Bass Coast Amendment C152 – Wonthaggi North East PSP

Changes Report

November 2021

Figure 15 - Utility Plan Comparison

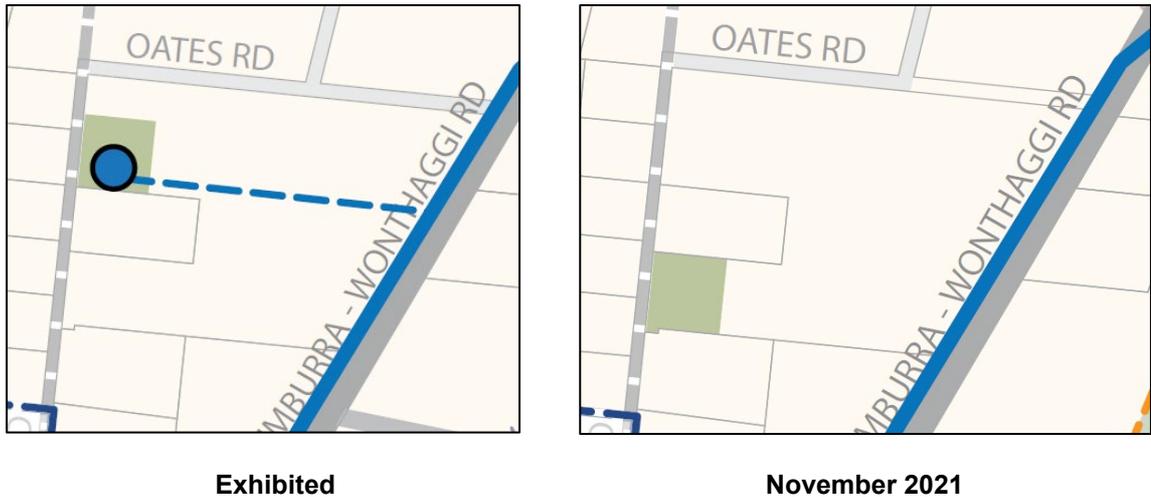
In response to the relocation of LP-05 as discussed in Section 3.0.7, South Gippsland Water were consulted regarding the location of a booster pump station shown in the same location as LP-05 in the exhibited version of the Utilities Plan. South Gippsland Water advised that the booster pump station was no longer needed in that location as they had plans to co-locate a booster pump station at their existing facility, and therefore recommended that the asset be removed from the PSP.

Plan 12 – Utilities has subsequently been amended in the November 2021 PSP to remove reference to the previously proposed booster pump station. This change is shown in Figure 15.

Figure 16 - Land Use Budget Plan Excerpt

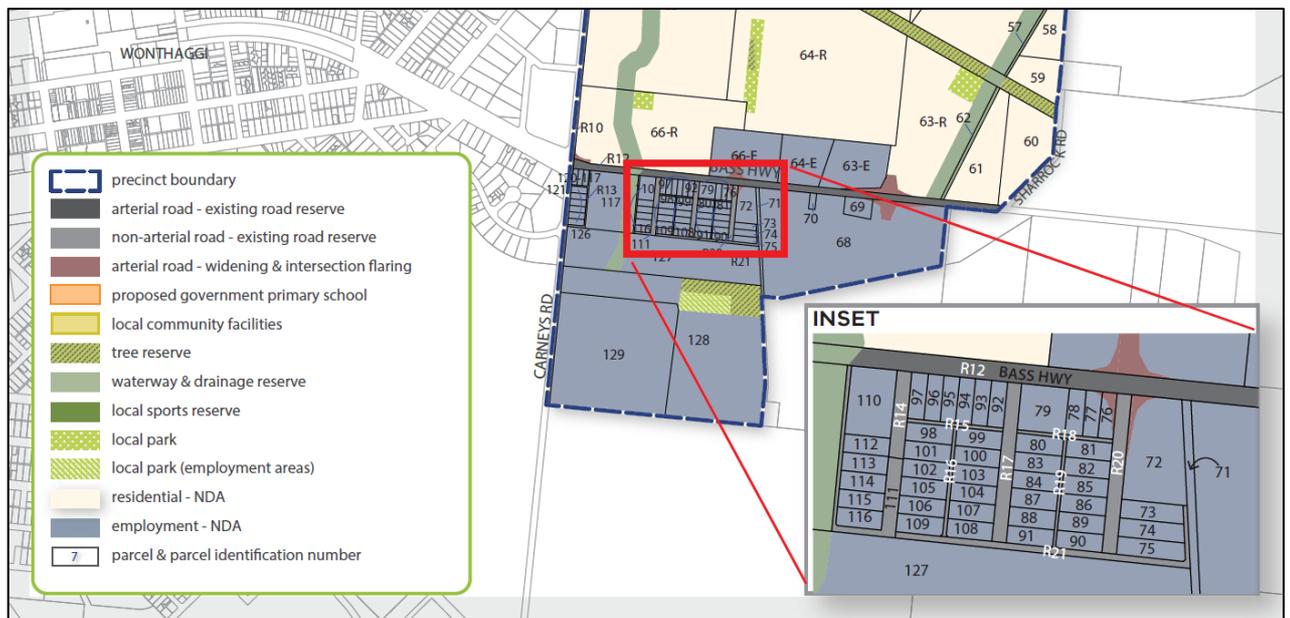
On the exhibited version of the Land Use Budget Plan, it was difficult to discern the PSP Property ID numbering of properties 73-109. As a result, an inset has been added to the plan which shows the numbering of the properties clearly. An excerpt of the revised plan in the November 2021 PSP is shown at Figure 16.

Figure 18 - Excerpt from Plan 20 Public Transport and Path Network

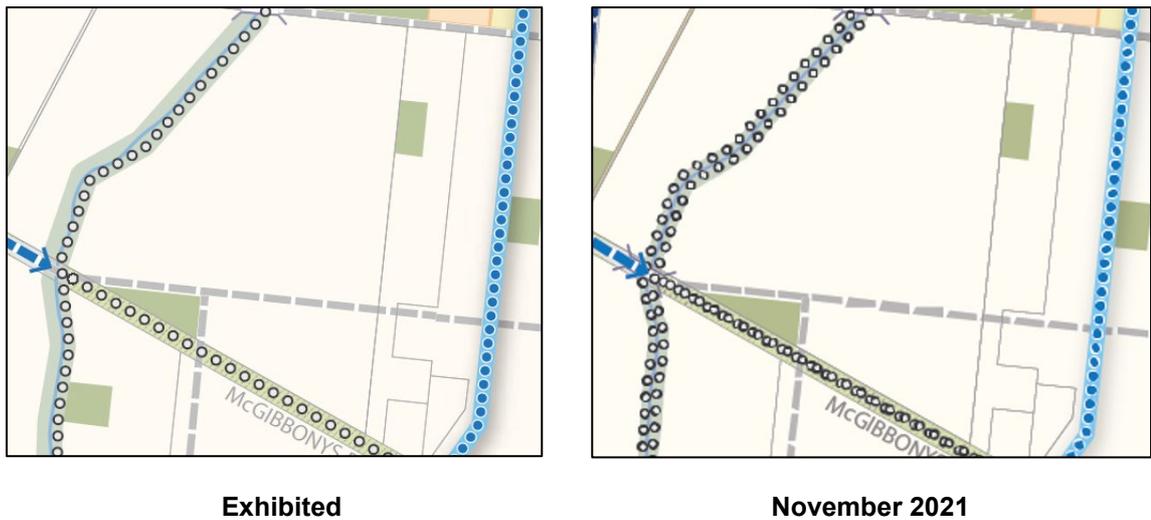
PSP Plan 10 was updated to clearly depict shared paths on both sides of the western north-south waterway. This change was made to ensure Plan 10 gave clear guidance on the expectation for provision of shared paths adjoining waterways that was consistent with Cross Section 14 and Requirement 46. An excerpt of the exhibited and current versions of Plan 10 showing this change is identified in Figure 18.

Figure 19 Proposed culvert crossings of the gas and water mains in 2019 Engeny Drainage Strategy

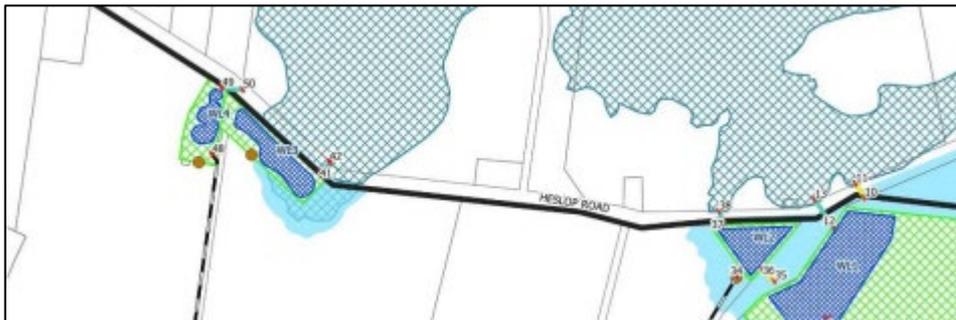
The VPA commissioned Engeny to undertake the necessary service proving, surveys and consultation with utility providers to develop the culvert concept designs proposed in the 2019 strategy (refer Figure 19) to safely cross the gas and water mains.

Consequently, Engeny included the revised approach to crossing the gas and water mains in their revised 2021 Drainage Strategy. The 2021 Drainage Strategy refined the design approach to crossing the gas and water mains at WL-01 and WL-02. Alluvium adopted the proposed approach on the basis that it has been investigated adequately. Alluvium have included the relevant contingency costs in for CU-08, CU-10 and CU-12 (refer to table in Section 4.1).

Table 4 - NVPP and DCP Project Summary

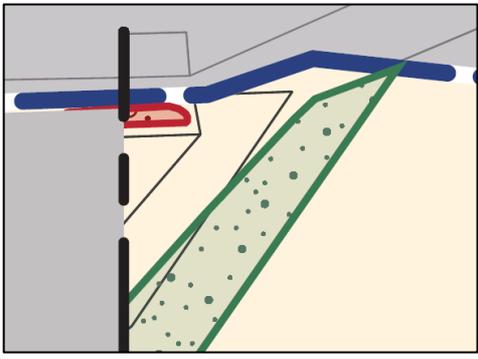
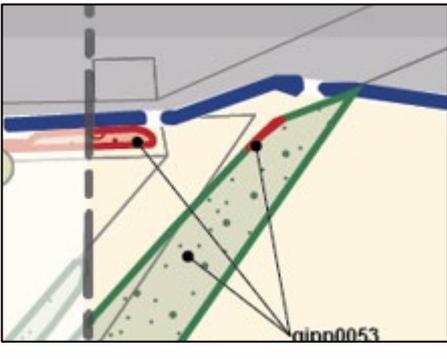
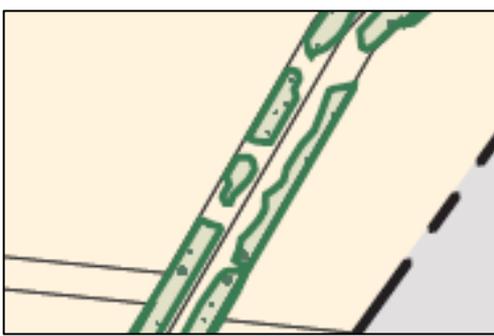
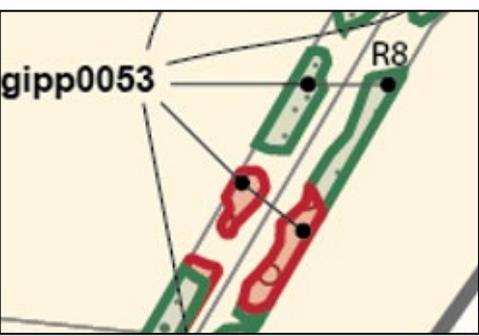
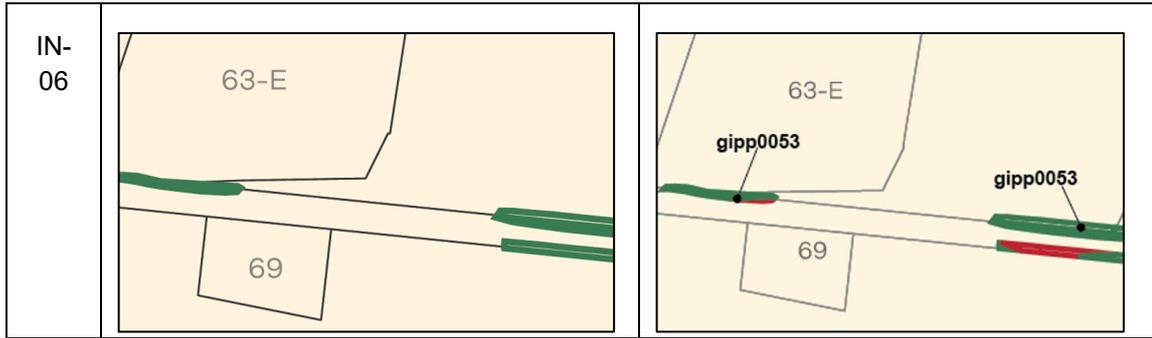
Following Tranche 1, the VPA performed a cross-reference of DCP projects and the NVPP and identified areas of overlap between the projects and vegetation shown as retained. It is noted that various DCP items were amended as part of the further work undertaken prior to Tranche 2. A list of affected projects and the resulting changes to the NVPP are identified in Table 4.

Changes to the NVPP have been made to account for direct areas of overlap with DCP Projects based on current designs, it is acknowledged that following the detailed design of infrastructure projects at the planning permit stage, additional vegetation removal may be required. It is noted that a planning permit may still be obtained to remove vegetation that the NVPP shows as *to be retained*, promoting a targeted and site-specific approach to vegetation removal in order to minimise the removal, destruction or lopping of native vegetation required by project construction.

Figure 21 - Revised D-DPO Map

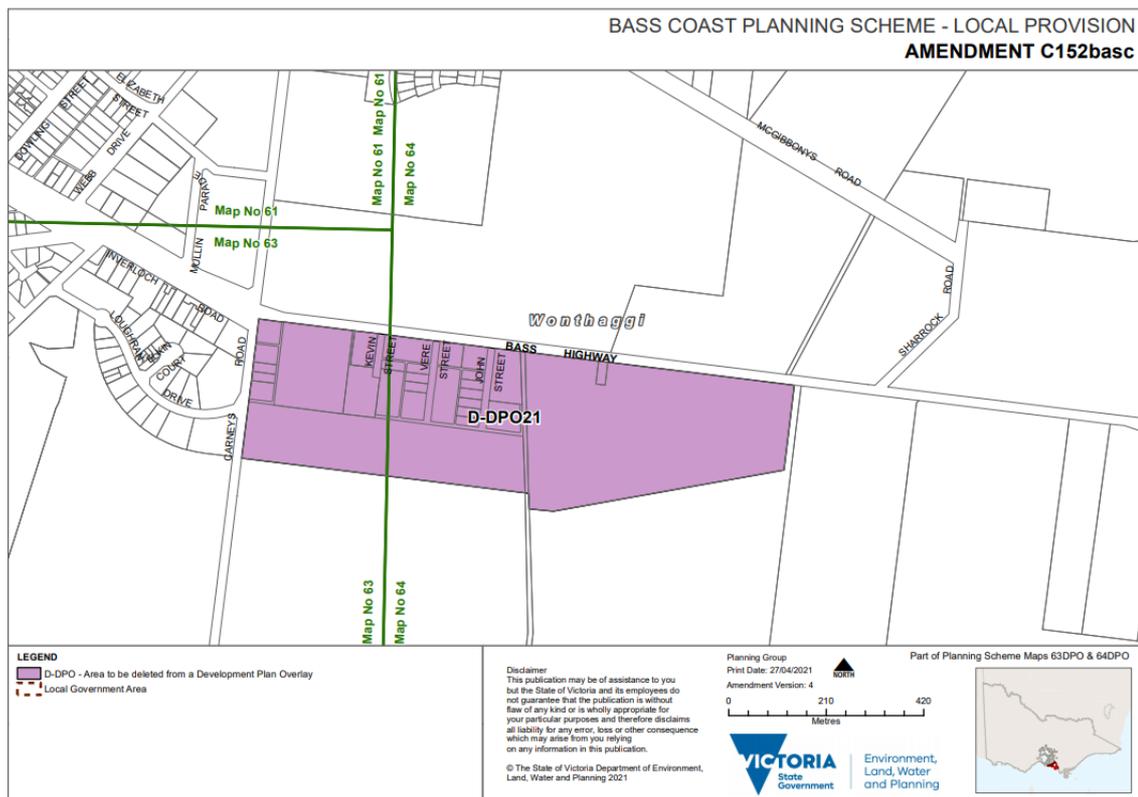
The properties to the south of the Bass Highway are being removed from the DPO but are to have the IPO2 applied to them as part of the draft amendment. Therefore, it was not the intention of the amendment to remove the DPO over any property without a similar provision replacing it.

An excerpt of the revised map is shown in Figure 21.

Figure 22 - Revised EAO Map

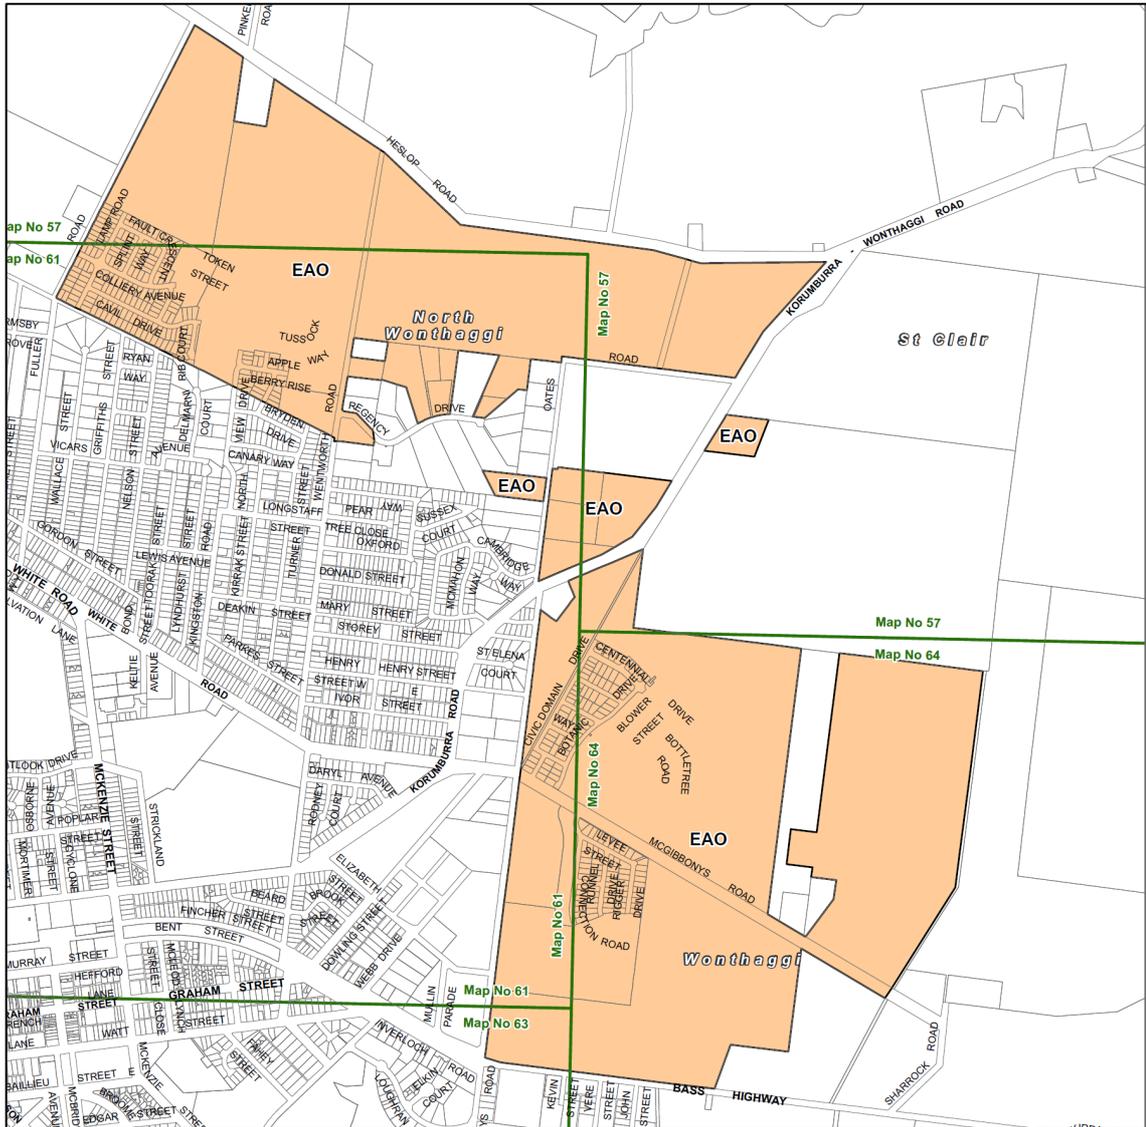
been retained, as a PSI remains the appropriate mechanism for potentially contaminated land intended for industrial uses, and the relevant IPO schedule will apply only to industrial properties.

An excerpt of the revised EAO map is provided In Figure 22. Clause 72.03 has also been updated to reflect the additional EAO Maps 63 and 64.
